Applies To: **See VEHICLES AFFECTED****July 20, 2007****Buzzing From the Engine at Low RPM**

(Supersedes 06-059, dated November 10, 2006, to update the information by the black bar)

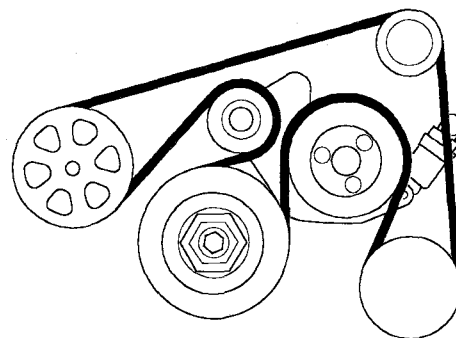
The drive belt layout allows drive belt tensioner noise to be heard in the passenger compartment.

Install a longer, re-routed drive belt.

1. Remove the original drive belt:
 - Refer to page 4-40 of the *2006–2007 Civic Service Manual*, or
 - Online, enter keywords **DRIVE BELT**, and select **Drive Belt Removal/Installation (R18A1 and R18A4 Engine)** from the list.
2. Install the new drive belt, and route it as shown.

NOTE: Use an appropriate tool for added leverage when setting the wrench on the auto-tensioner. The tensioner is hydraulic and should be moved slowly to relieve pressure on the belt. Applying excessive force to the tensioner can cause breakage.
